ADDENDUM NO. 1

**DATE ISSUED:
APRIL 23, 2021**

**BIDDING AND CONTRACT DOCUMENTS
FOR THE
CLEVELAND COUNTY SOLID WASTE
C&D LANDFILL E&SC IMPROVEMENT PROJECT**

**PROPOSED GRADING PLAN &
EROSION CONTROL MEASURES**

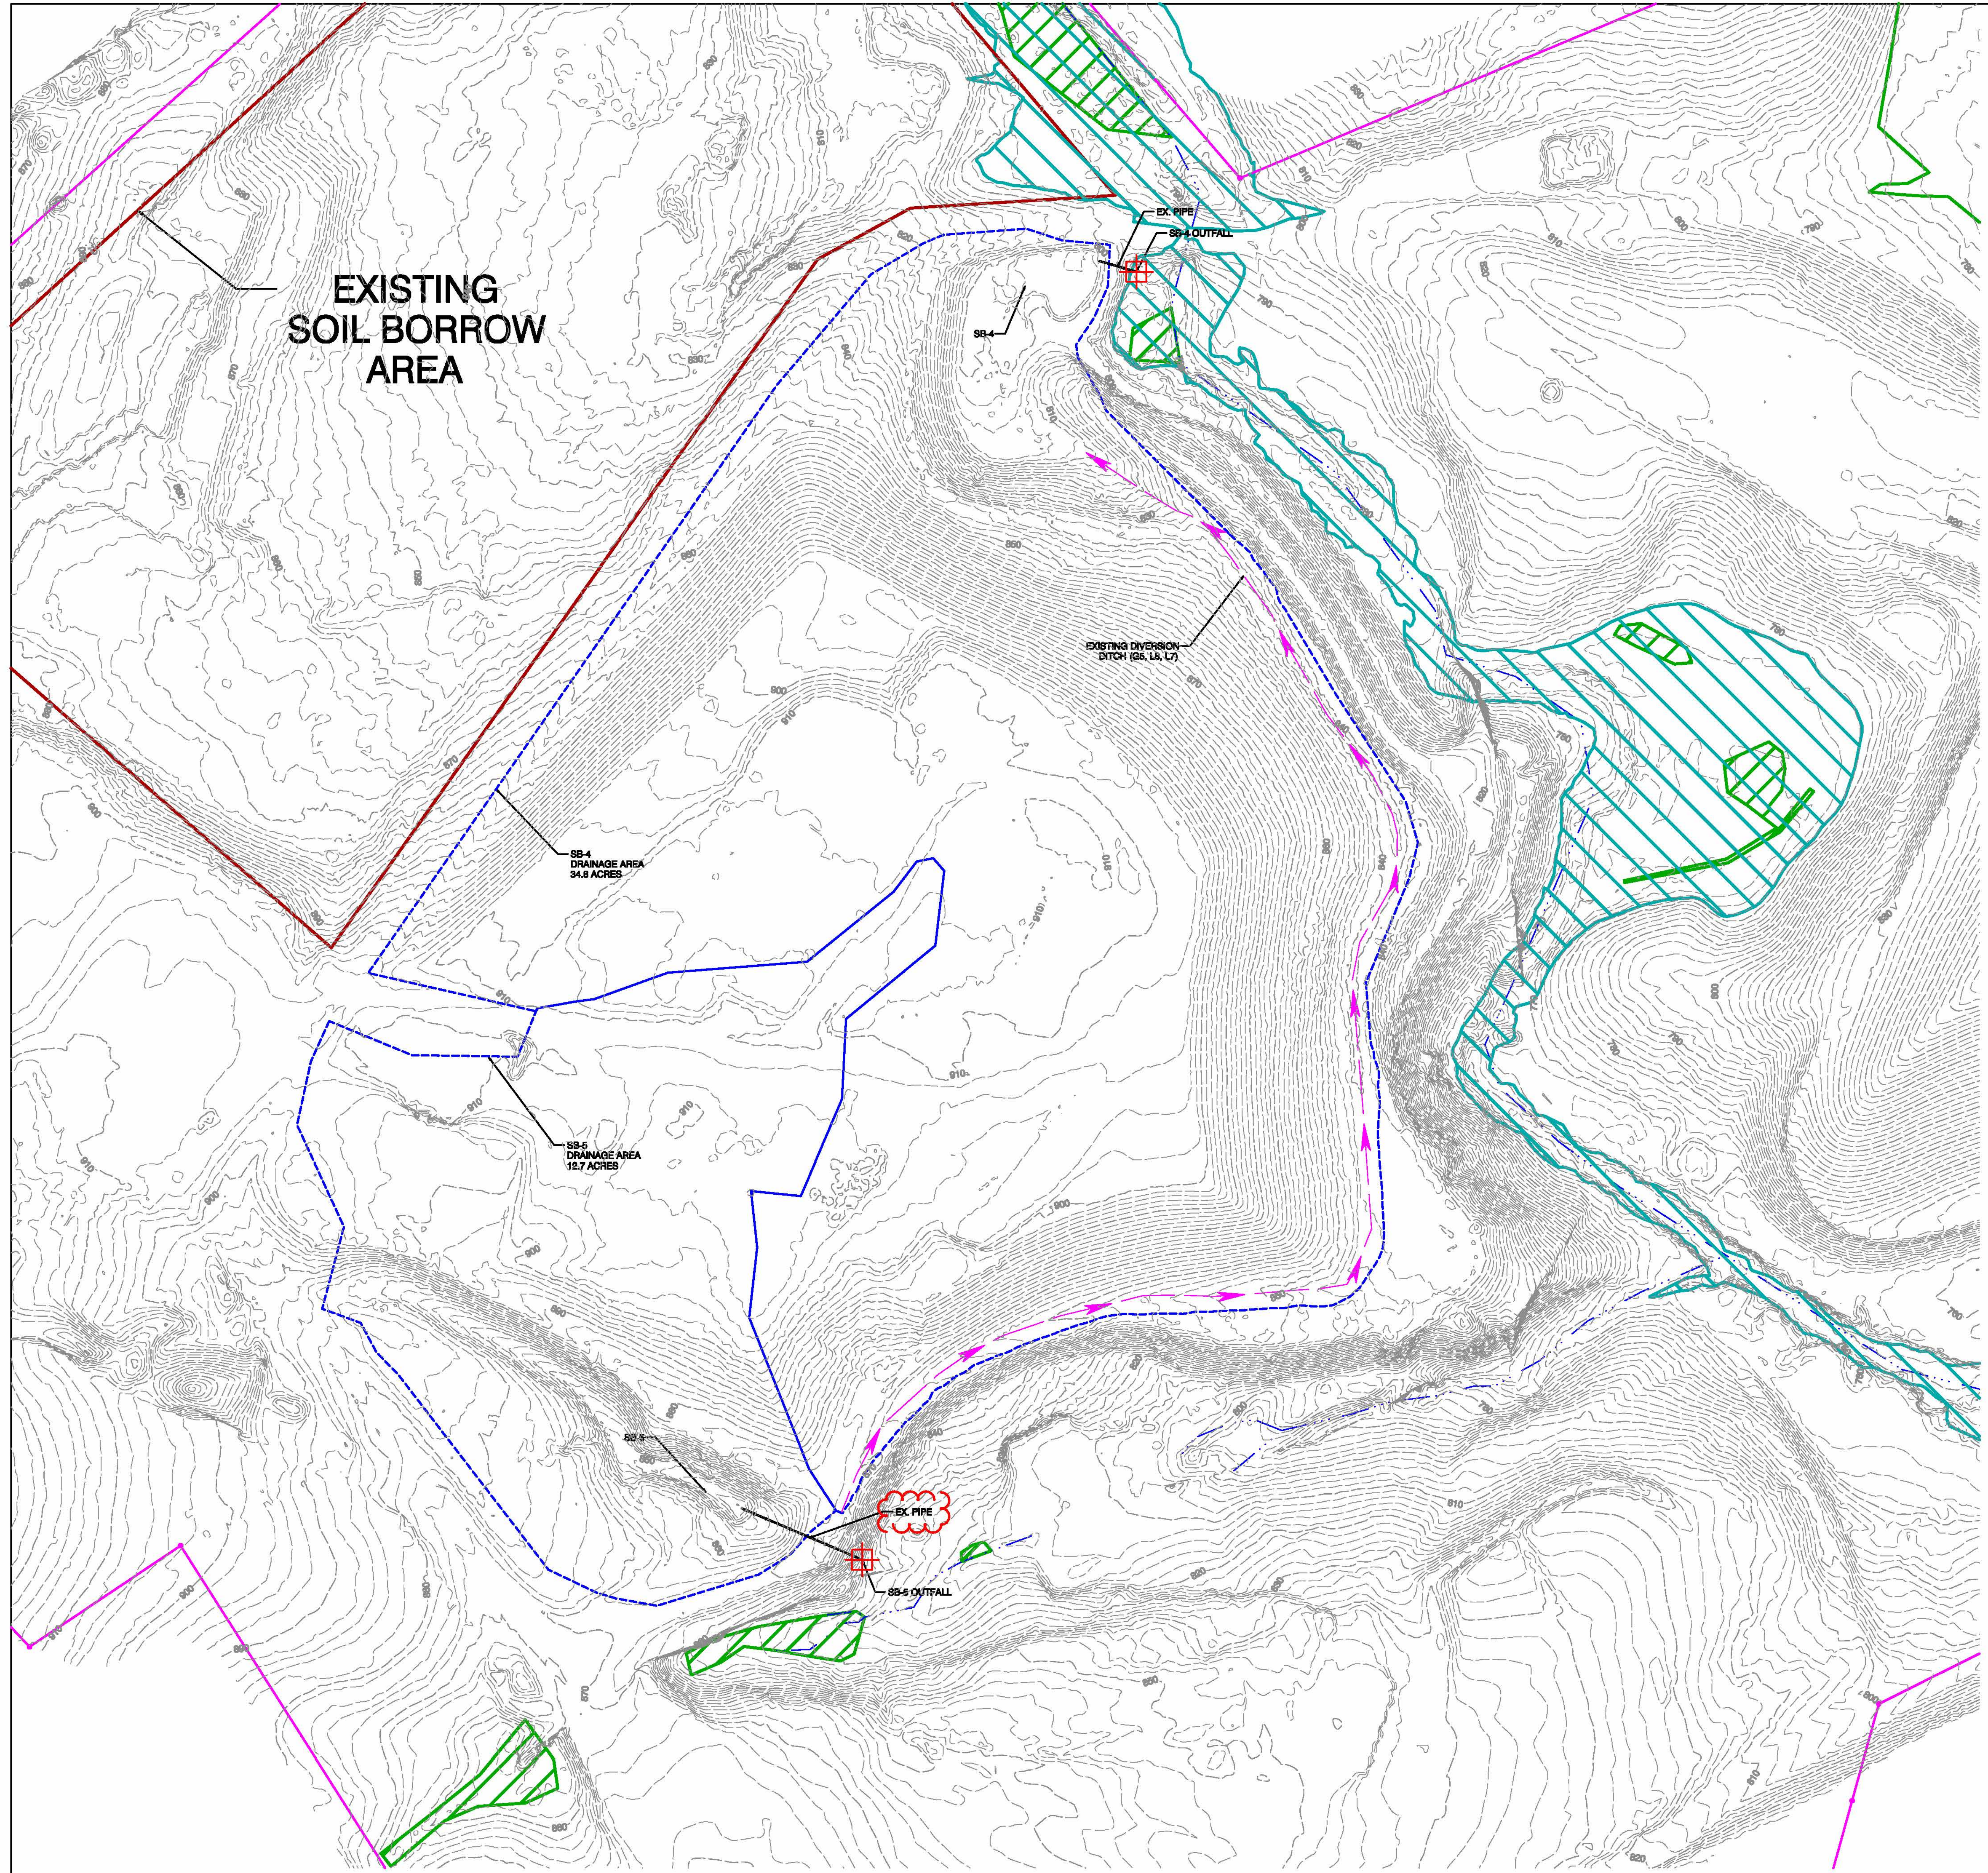
Cleveland County C&DLF Erosion & Sediment Control Plan: Drawing 3 dated February 24, 2021; Delete and replace with Drawing 3 dated April 22, 2021, attached.

NOTE: All modifications are marked with red cloud outline for ease of identification.

**DRAWING
2**

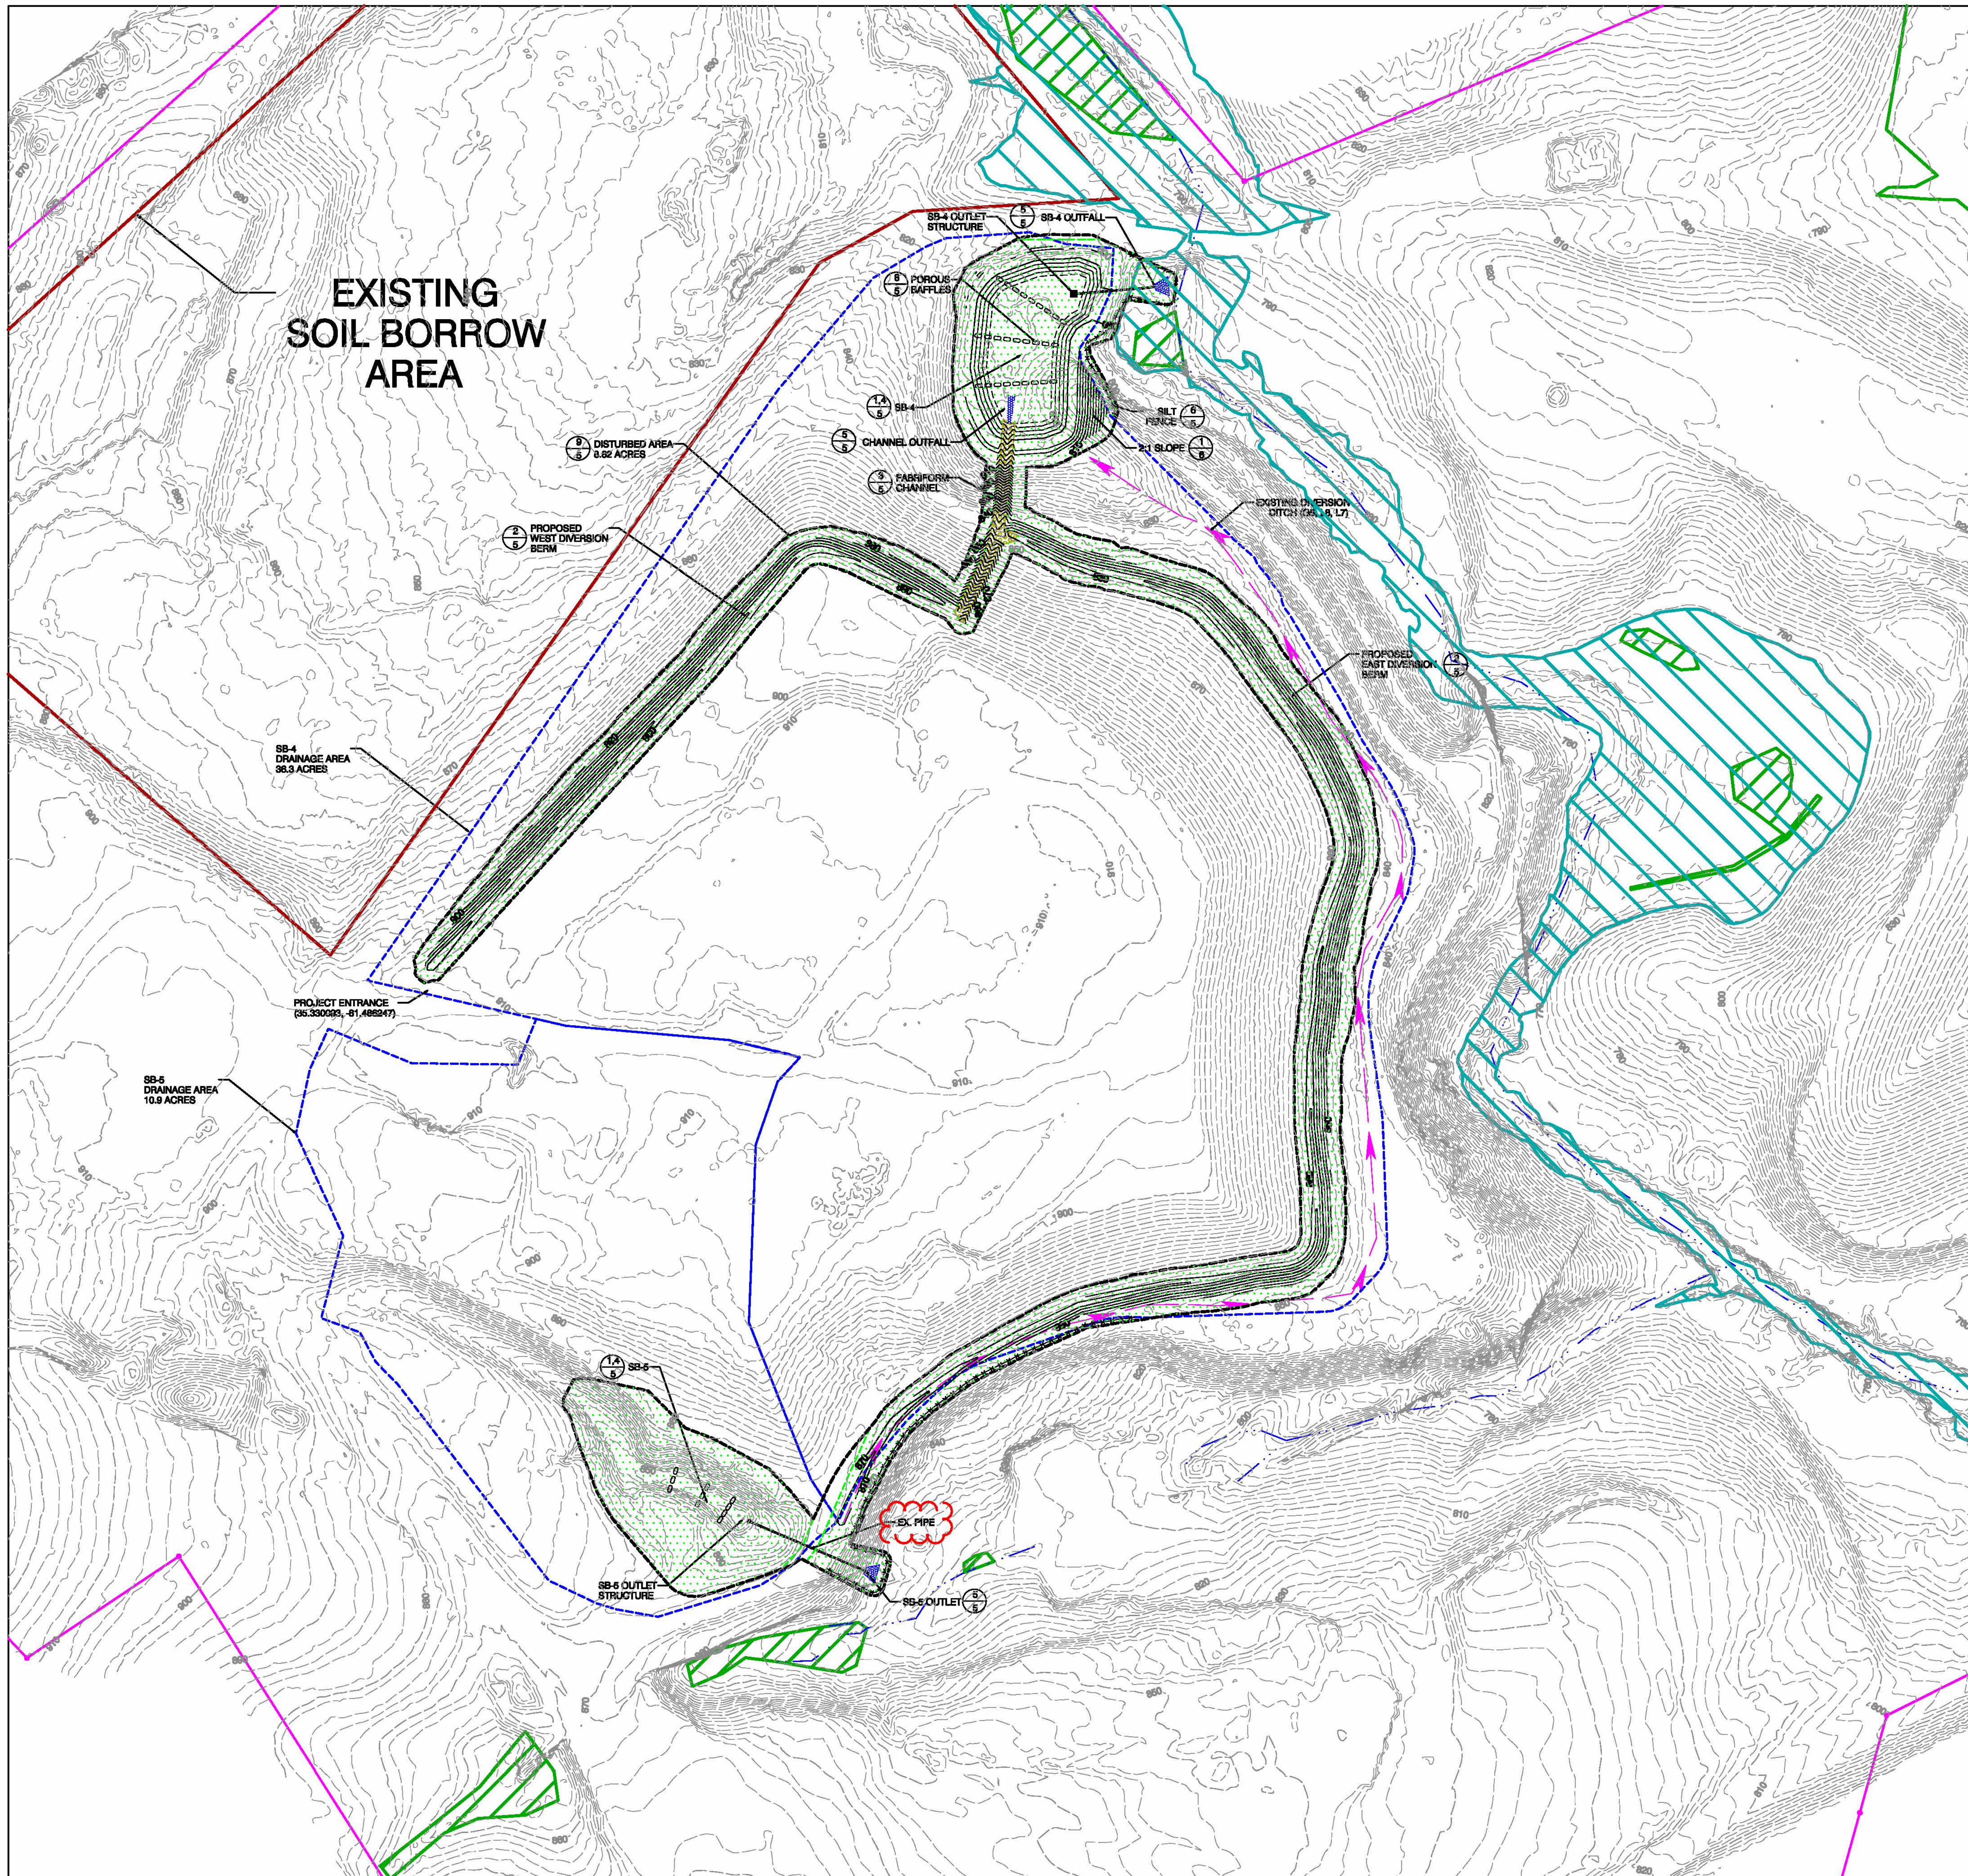
Cleveland County C&DLF Erosion & Sediment Control Plan: Drawing 2 dated February 5, 2020; Delete and replace with Drawing 2 dated April 22, 2021, attached.
